**KING CITY PLANNING COMMISSION
MEETING**

CASE NO. LU 18-03 (NORTHWEST CORNER OF SW 131ST AVENUE AND SW FISCHER ROAD), ZONE CHANGE, SUBDIVISION, TREE REMOVAL, AND GOAL 5 SAFE HARBOR REVIEW.

TO: King City Planning Commission
FROM: Keith Liden, Planning Consultant
SUBJECT: SW 131st/Fischer Zone Change and Subdivision Staff Report - File No. LU 18-03
Zone Change and Subdivision Application
DATE: November 28, 2018

TO: Michael Weston, City Manager
Keith Liden, City Planner

PRELIMINARY PLAT 131ST / FISCHER PROJECT FOR TIM HORST CITY OF 'KING CITY'

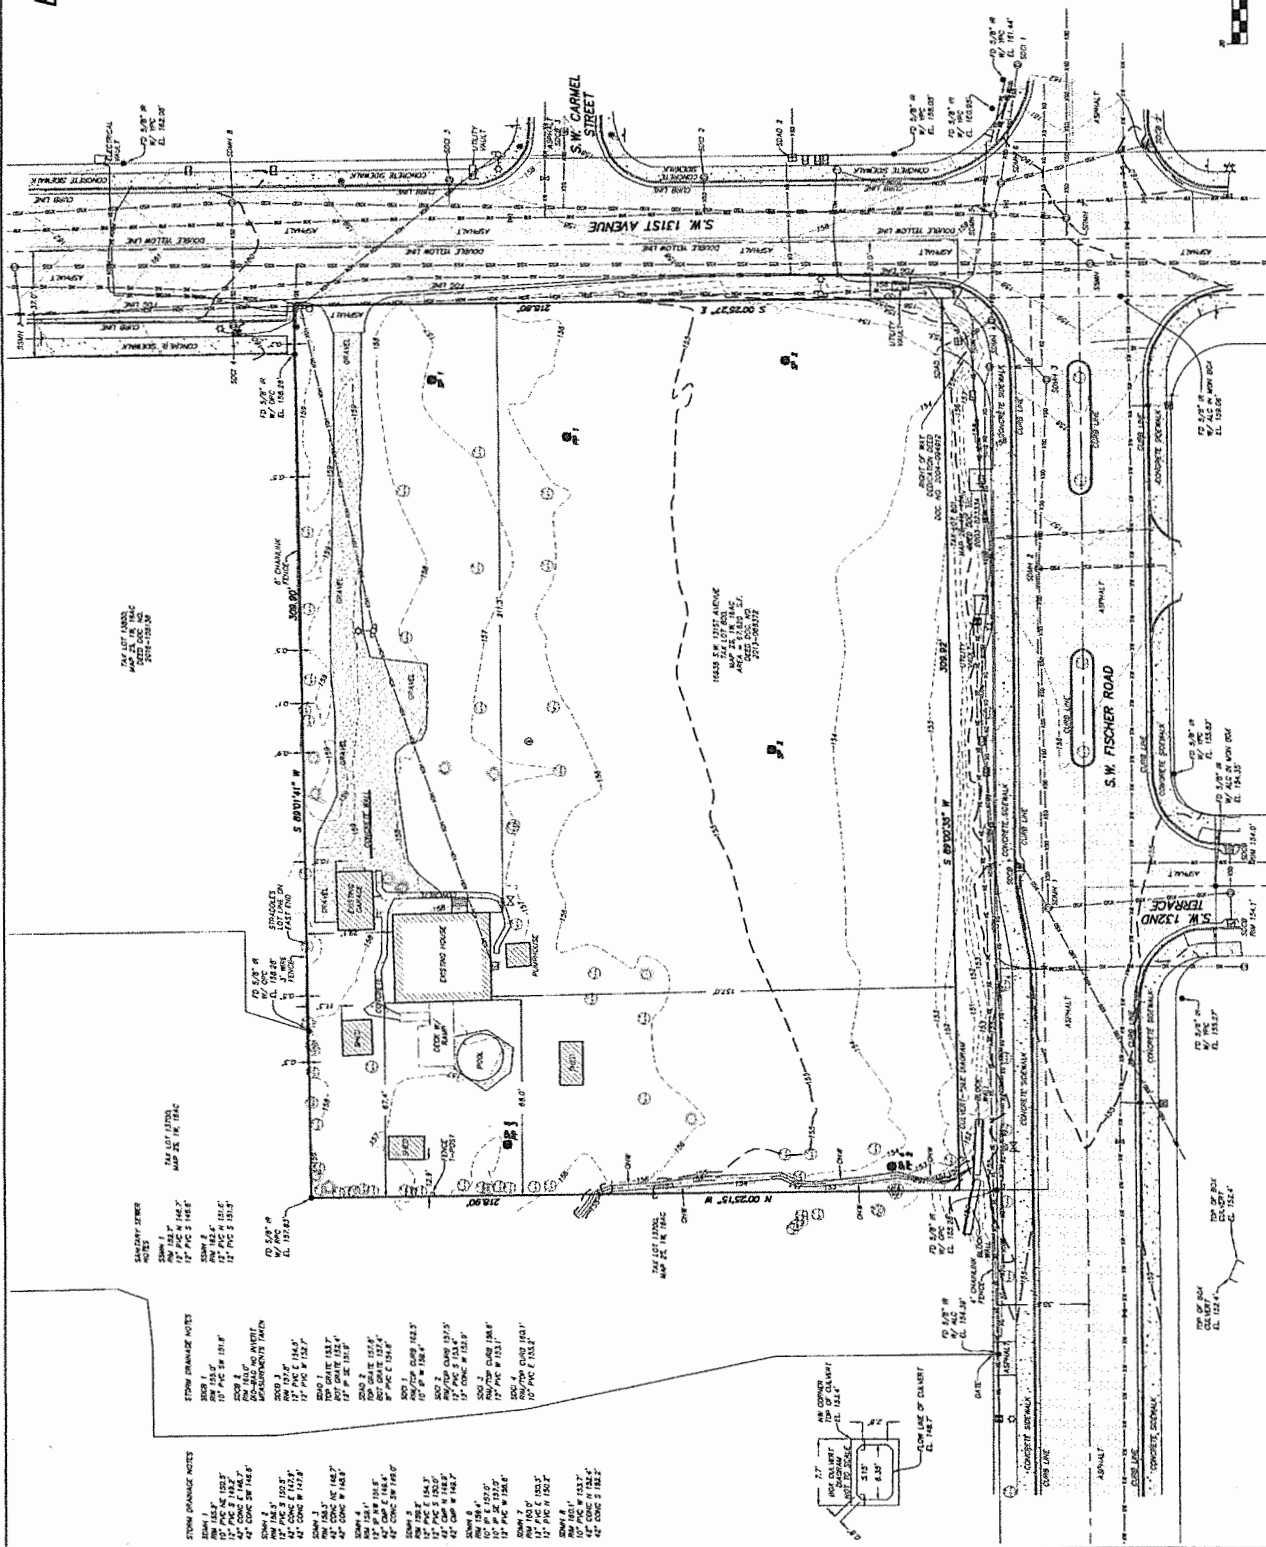
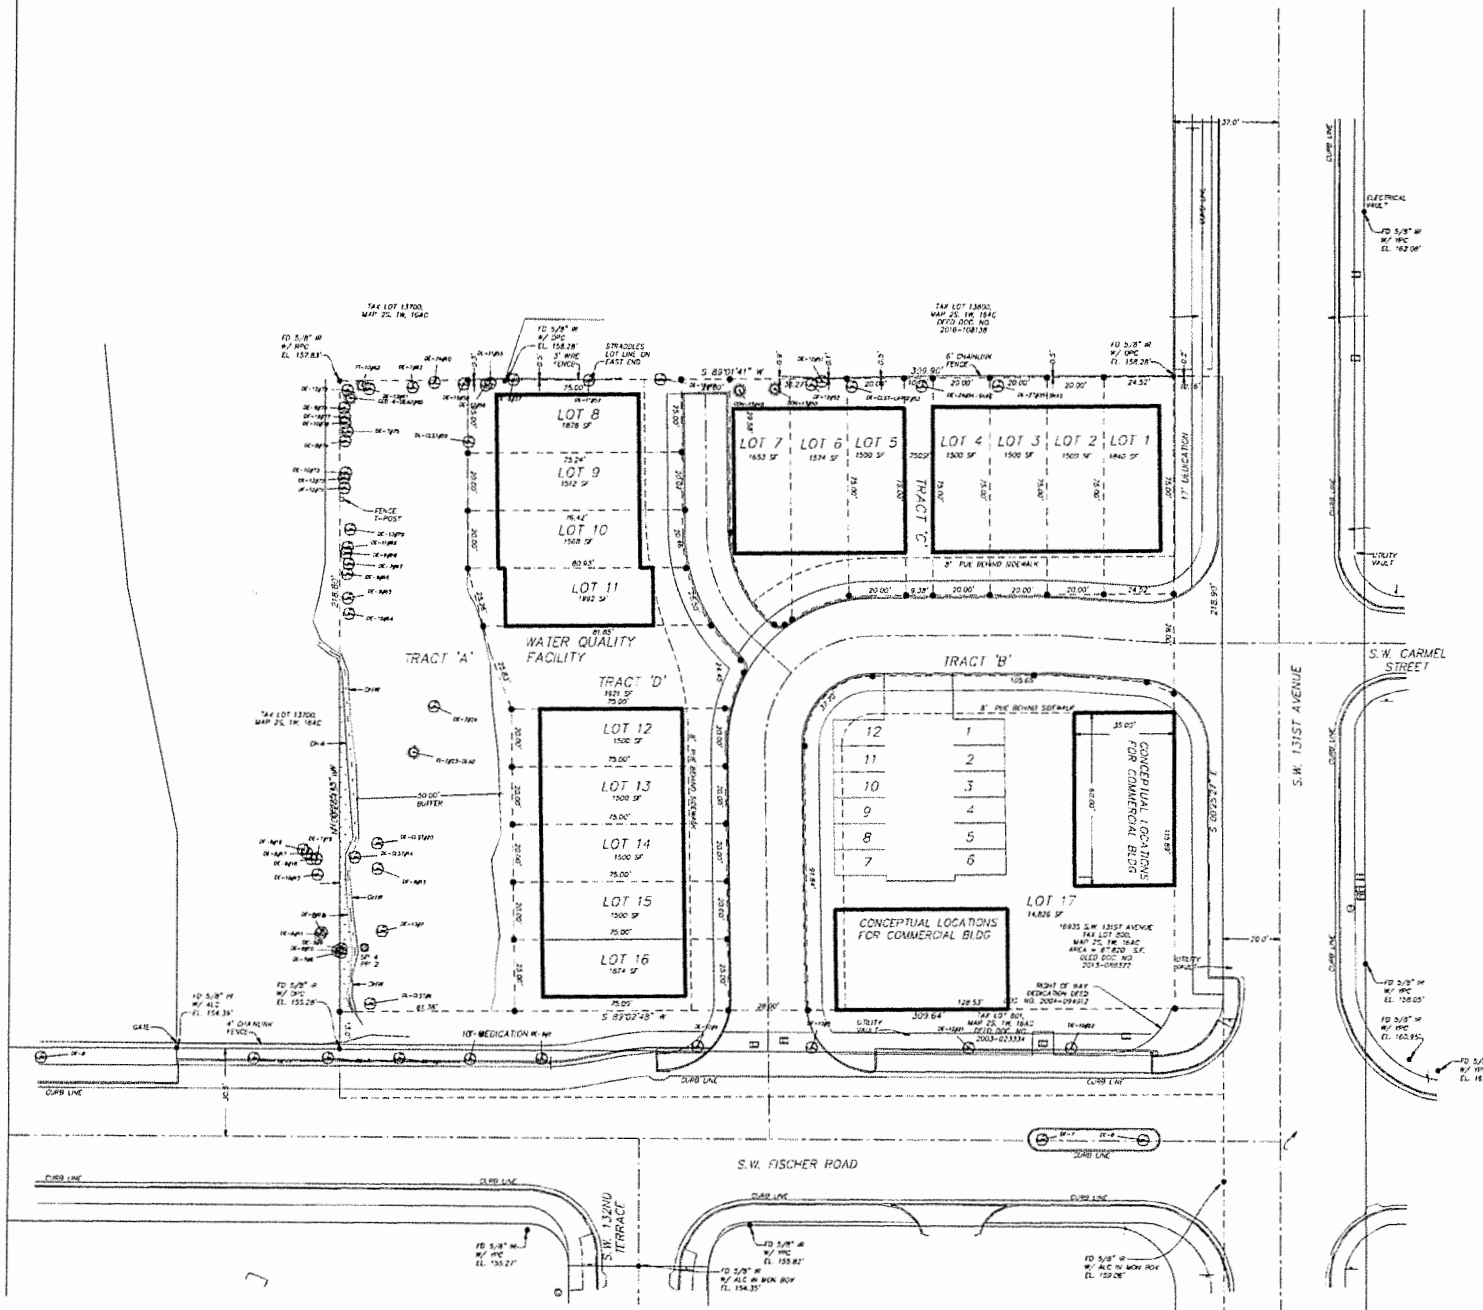
- **Access.** The private street that is proposed in the application. The City has requested that it be publicly open.

Proposed pedestrian access improvements include completing the missing sidewalk along the SW 131st Street frontage, sidewalk along both sides of the 28-foot wide private street, and sidewalk on one side of the 22-foot wide private street. An additional pedestrian connection is proposed within Tract C between Lots 4 and 5 to connect with an existing public walkway, which is located within the recently completed apartment complex to the north.

17. General access is proposed from both SW 131st Avenue and SW Fischer Road through a 26-foot wide paved street within a 28-foot right-of-way, approximately 300 feet long to access all lots. To meet City standards, the access shall be through a public 28-foot wide paved street within a 39-foot right-of-way to include the sidewalks on both side of the main street. In addition, access to Lot 7 through Lot 11 is proposed thru a private paved alley, approximately 89 feet long. Plans identify the access to be 22 feet wide, however the actual measurement shows 17 feet between property lines. Corrections are required. As proposed, circulation internal to the Development allows adequate circulation of fire trucks provided the paved area is adjusted to 28 feet, however final approval from TVFR regarding safety and firefighting apparatus access is still required.

18. As currently proposed, the public sidewalks are outside of public right-of-way. All curb-tight sidewalks on the main street are to be on public right-of-way. Design shall show a cross section to illustrate the proposed right-of-way and 8-foot wide utility easement.

PRELIMINARY PLAT 131ST / FISCHER PROJECT FOR TIM HORST CITY OF 'KING CITY'

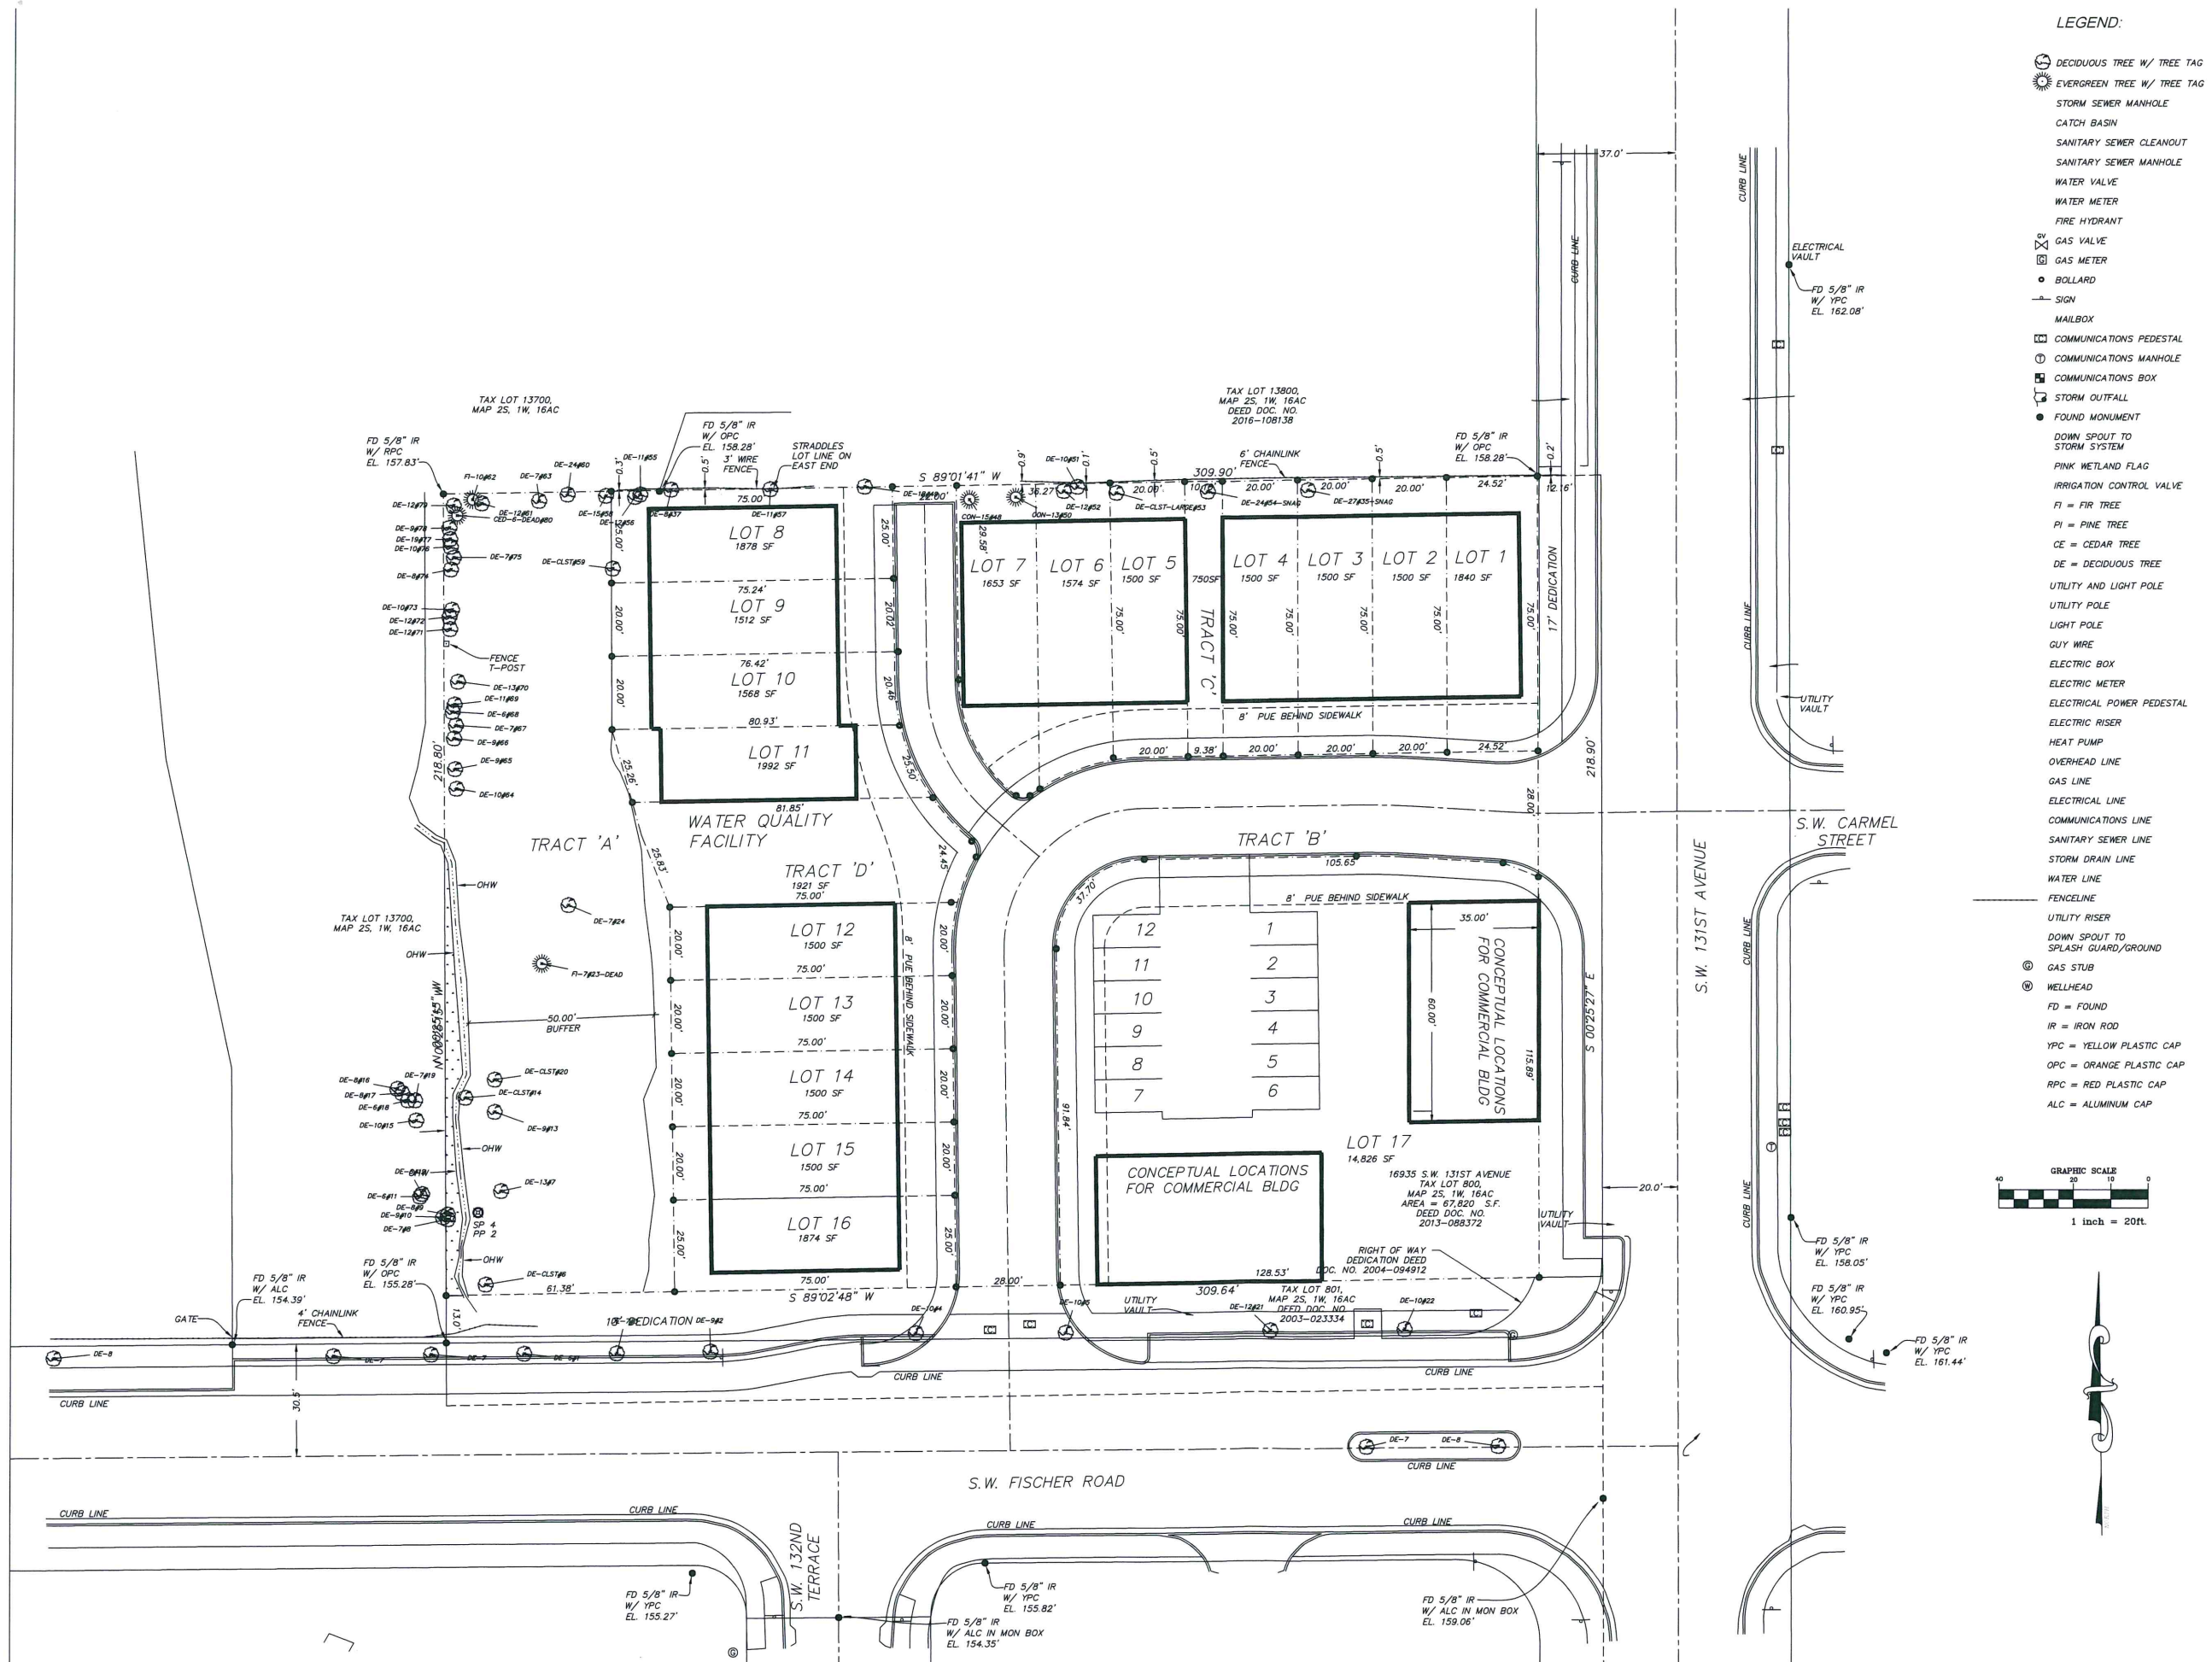
The landscaping plan (Exhibit 8 Plan Set, Sheet P4) includes trees along the private street frontages within the development and along SW 131st Avenue and SW Fischer Road. Section 16.124.060 requires yard trees have an average spacing of 25 to 40 feet, depending upon the mature size of the tree. Trees are shown with spacing of 20 to 30 feet. However, the plan does not indicate a proposed tree species. The tree species and spacing should be reviewed as a condition of approval to ensure appropriate street tree selection and planting. Landscaping for Lot 17 shall be reviewed as part of a future site development review application.

The applicant proposes to provide a one-car garage for each unit. Although house plans have not been provided, the landscaping plan (Exhibit 8 Plan Set, Sheet P4) suggests that each townhome is envisioned to have a recessed garage door, providing sufficient room to park an additional vehicle in the driveway with sufficient room to not block the sidewalk (18-foot garage setback is required from the edge of the sidewalk). In addition, it appears that approximately 8 on-street parking spaces will be possible on the internal street, plus 8-9 parallel spaces along the SW 131st Avenue and SW Fischer Road frontages. Required parking for development on Lot 17 will be determined as part of a future site development review application. Comments have not been received from Tualatin Valley Fire and Rescue (TVFR). However, in the review of previous subdivisions, TVFR consistently has not allowed parking on one side of a two-way street that is less than 28 feet wide. The applicant will either need to remove parking on one side or widen the street to a curb-to-curb minimum of 28 feet.
